LR-N96099

**SPENT FUEL POOL COOLING SYSTEM DESCRIPTION
SALEM GENERATING STATION
UNIT NOS. 1 AND 2
DOCKET NOS. 50-272 AND 50-311**

LR-N96099
ATTACHMENT 1
44 PAGES

NEW UFSAR FIGURE 9.1-2B
MAXIMUM DENSITY SPENT FUEL STORAGE MODULE
REGION II

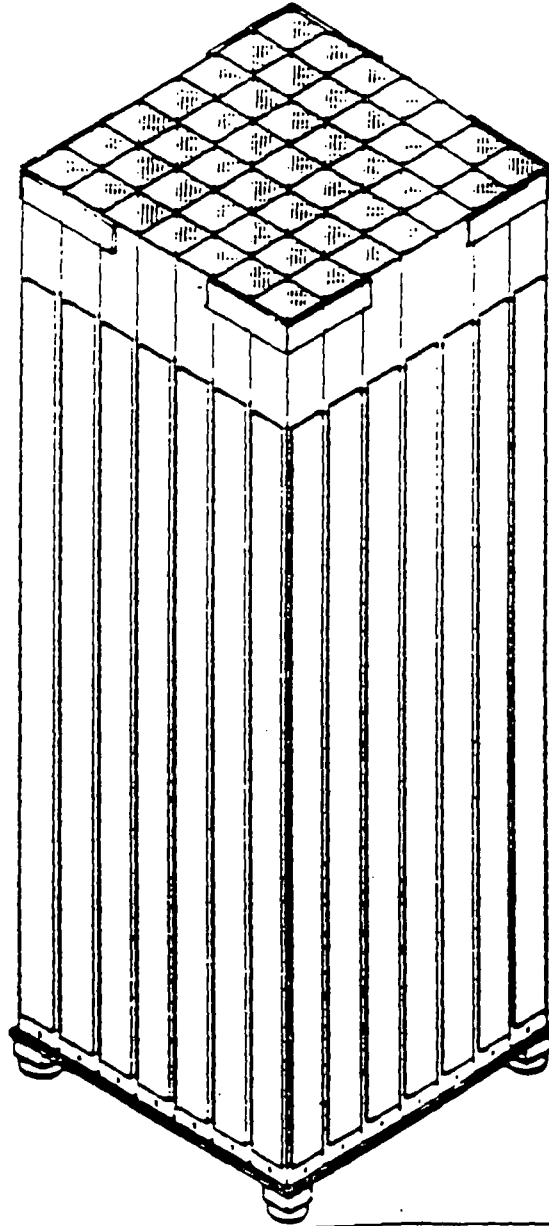
With the implementation of reracking in 1994, nine existing Exxon racks were replaced with nine maximum density Holtec racks, shown on Figure 9.1-2B. The locations of new rack modules are shown on Figures 9.1-3 and 9.1-3A. These racks have a single poison panel between adjacent austenitic stainless steel surfaces and serve as Region II. The significant components of these racks are: 1) Box cell assembly, 2) Boral panel and Sheathing, 3) Formed and Periphery cells, 4) Baseplate, 5) Support legs.

INCREASED CAPACITY POOL LAYOUT (1632 CELLS)
 SALEM UNITS 1

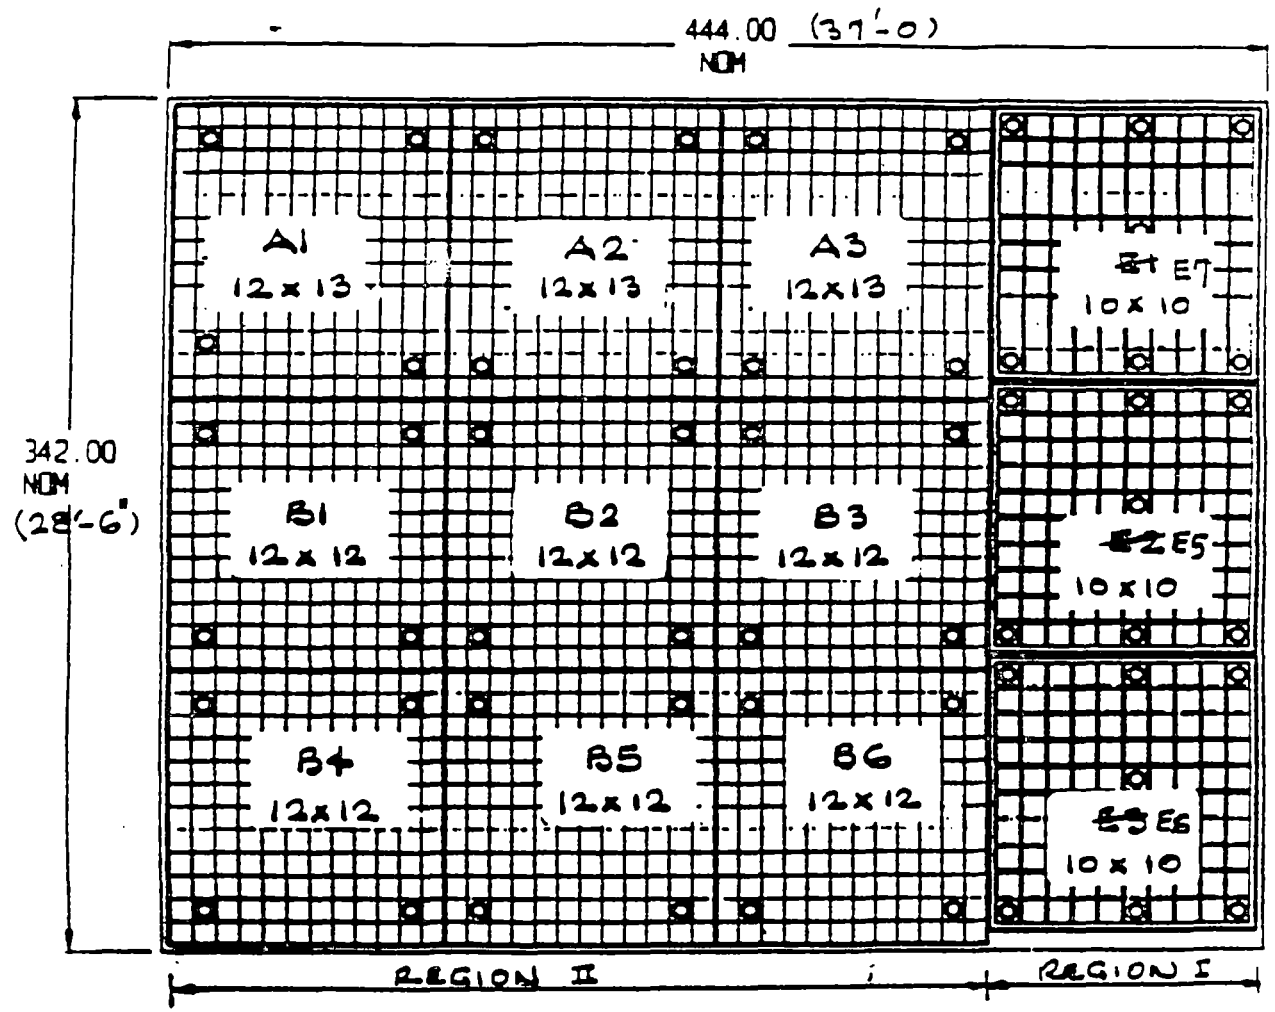
With the implementation of reracking in 1994, three previously installed Exxon racks were retained which are of poisoned flux trap construction to serve as Region I. Each rack module retained in the pool for this purpose consist of one hundred storage cells and has cross-sectional dimensions of 109.5" X 109.5". The locations of the existing modules are shown on Figures 9.1-3 and 9.1-3A.

NEW WFSAR FIGURE 9.1-3A

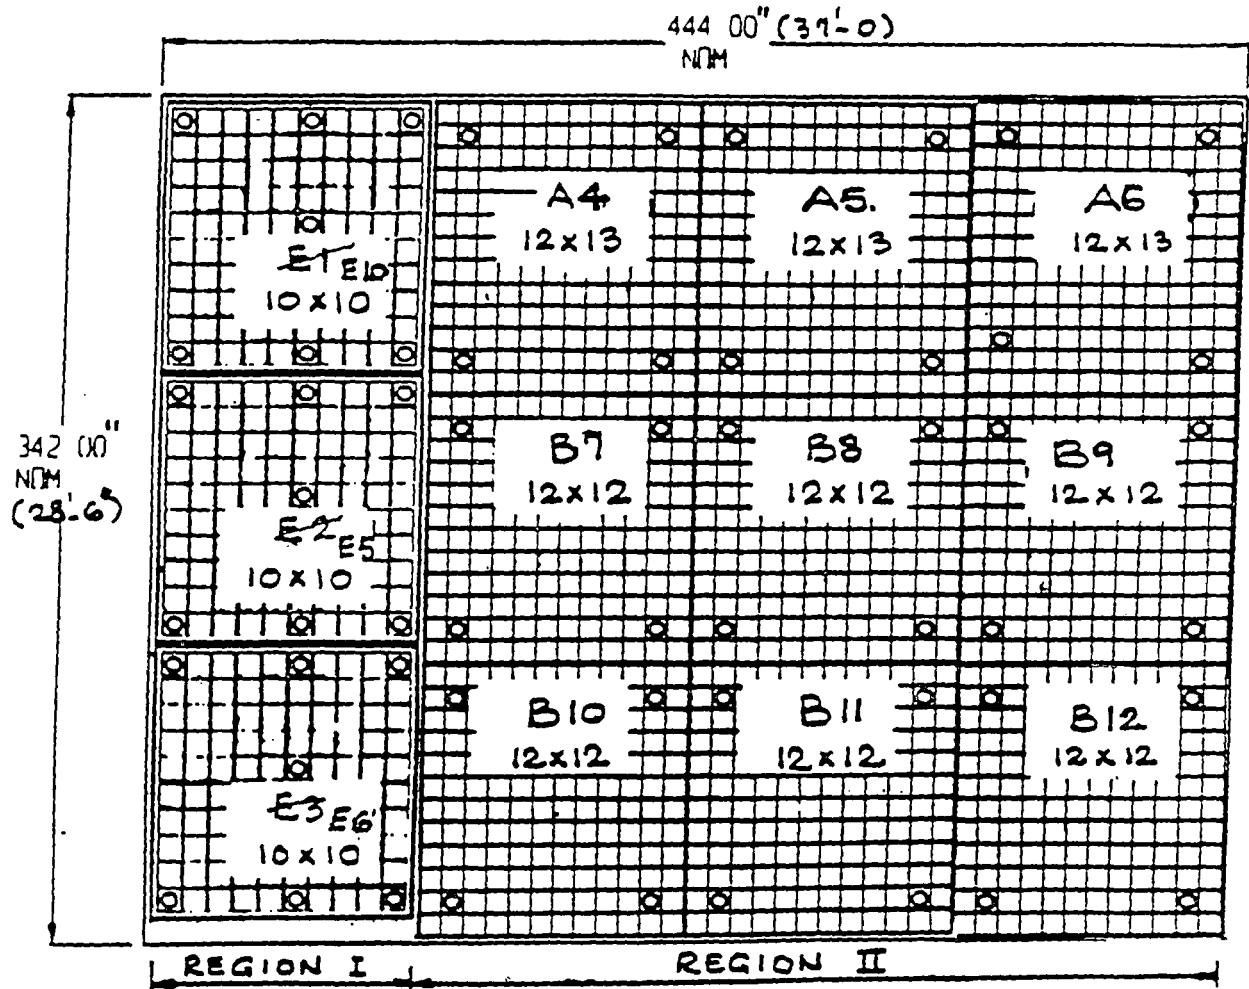
~~3 x 10 x 10 = 300 CELLS~~
~~5 x 12 x 12 = 864 CELLS~~
~~3 x 13 x 12 = 468 CELLS~~
 = 1632 CELLS

* UNIT 2 SPENT FUEL POOL RACK LAYOUT "

Figure 9.1-3C

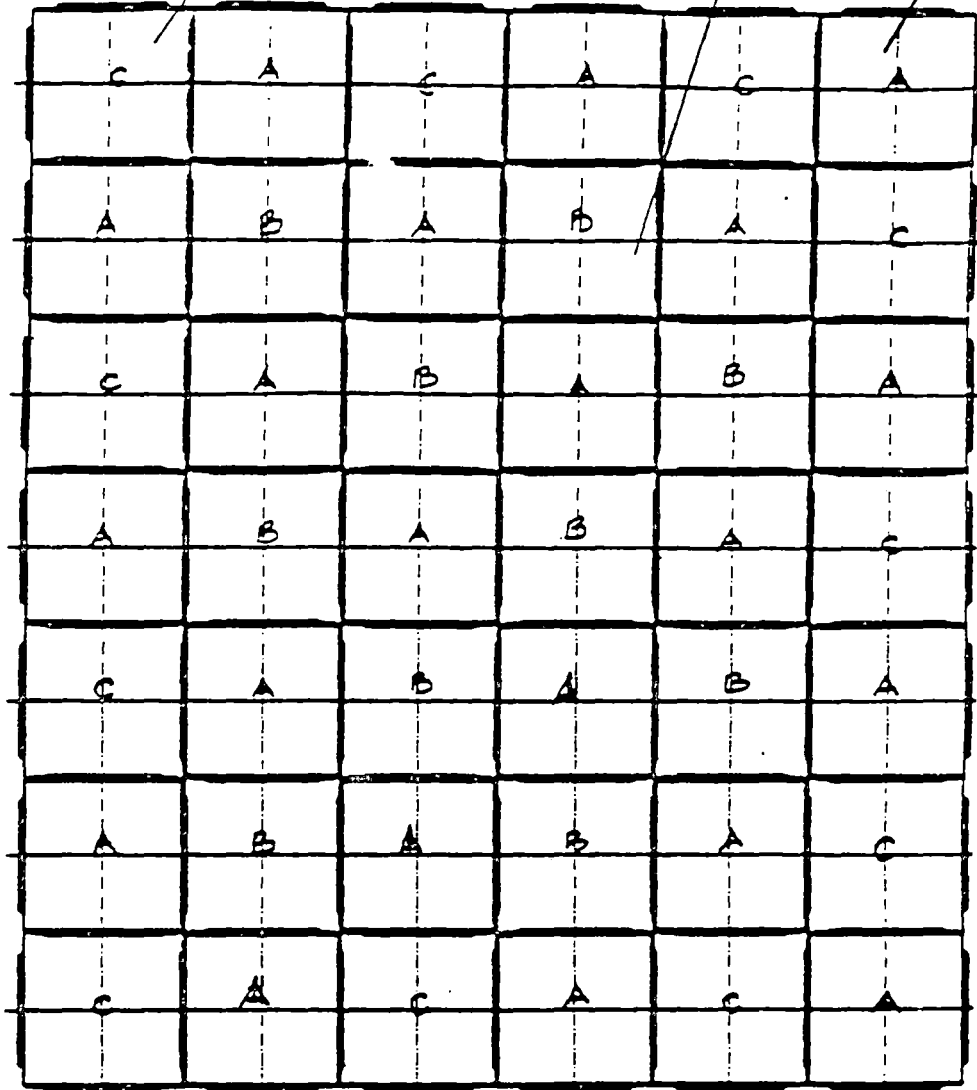
The box cells are fabricated from two precision formed channels by continuous seam welding. The inside (nominal) dimension of the box is 8.86 x 8.86 inches. Each box constitutes a storage location. See Figure 9.1-3C.

The boxes with integrally connected sheathing, are arranged in a checkerboard array to form the storage cell rack module. This way, Formed cells (interior boxes) are automatically created. The inter-box welding and pitch adjustment are accomplished by small longitudinal connectors. Flat plates are welded to the edges of the boxes at the outside boundary of the boxes to create the periphery cells. See Figure 9.1-3C.

MAXIMUM DENSITY REGION II
 SPENT FUEL STORAGE CELL Cross Section
 Updated FSAR Figure 9.1-3E

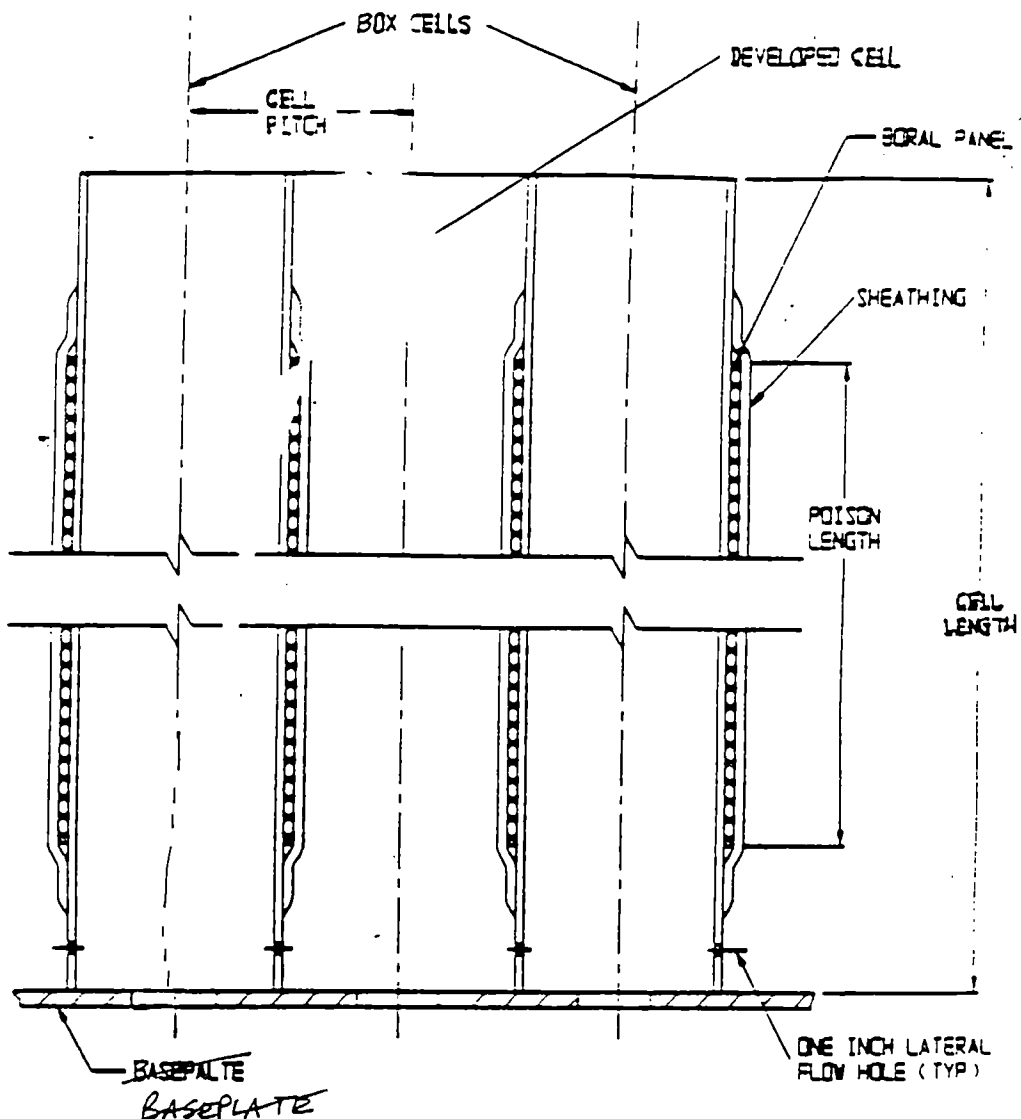
Boral is used as the neutron absorber material. The boral panels are manufactured by using a homogenized particulate mixture of Boron carbide and aluminum powder sandwiched between thin aluminum sheets using a hot rolling process. The boral panels are placed in the customized flat depression region of the sheathing, which is laid on a side of the "box". The flanges of the sheathing are attached to the box on all four sides using intermittent weld. The sheathing serves to locate and position the boral panel accurately, and to preclude its movement under seismic conditions. See Figures 9.1-3D and 9.1-3E.

PUBLIC SERVICE ELECTRIC AND GAS COMPANY SALEM NUCLEAR GENERATING STATION	MAXIMUM DENSITY REGION II SPENT FUEL STORAGE BACK	<u>BASEPLATE</u>
	LOCATION PSAR	FIGURE 9.1-3F

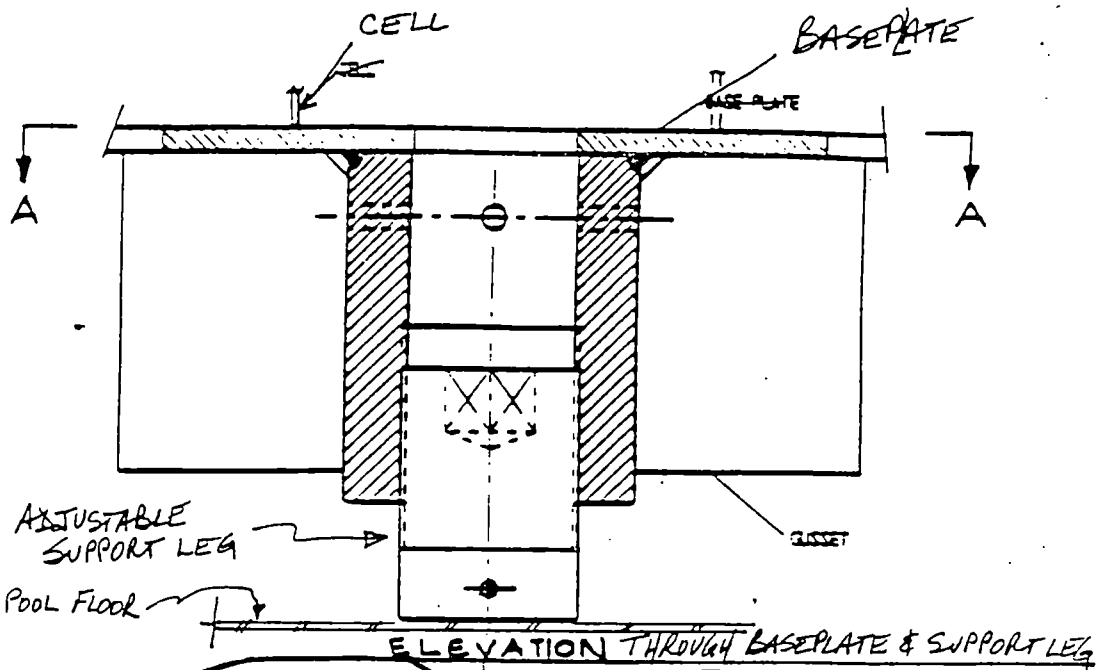
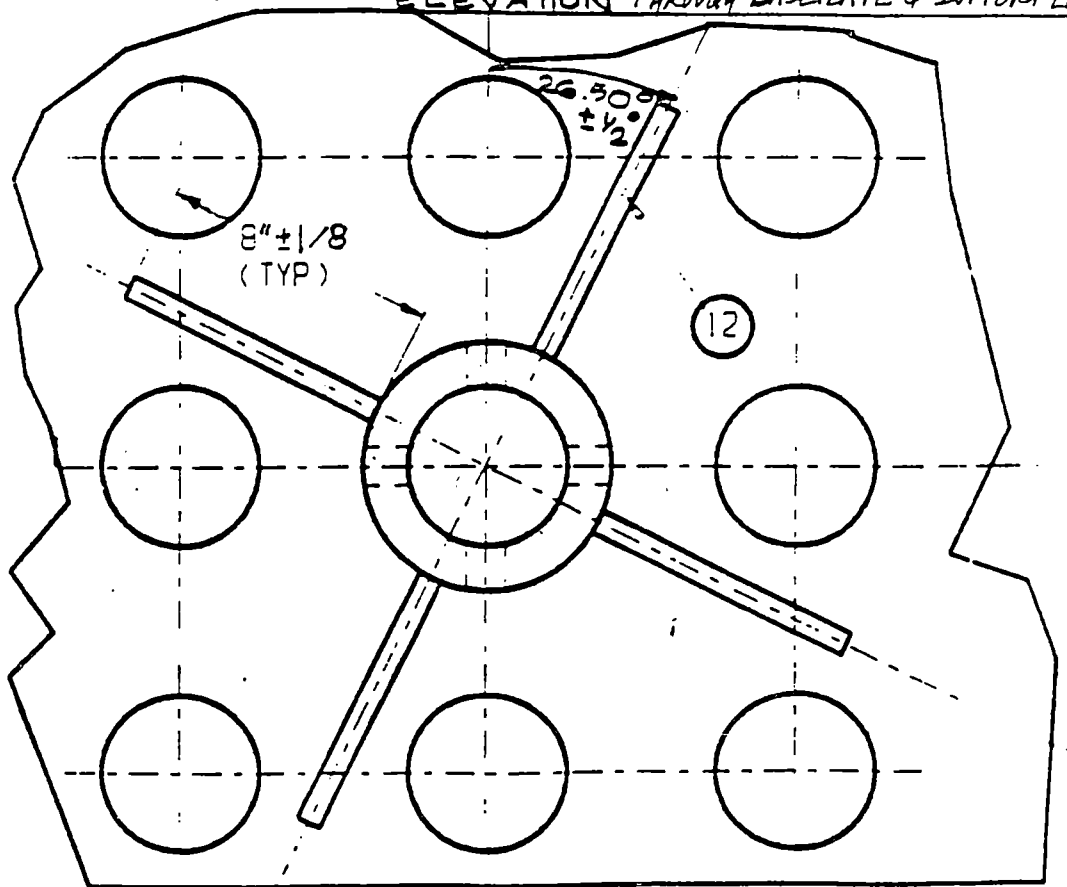
The baseplate provides a continuous horizontal surface for supporting the fuel assemblies. See Figure 9.1-3F.

All support legs are adjustable type. The top portion is made of austenitic stainless steel material. The bottom portion is made of SA564 type 630 age hardened stainless steel to avoid galling problems. See Figure 9.1-3F.
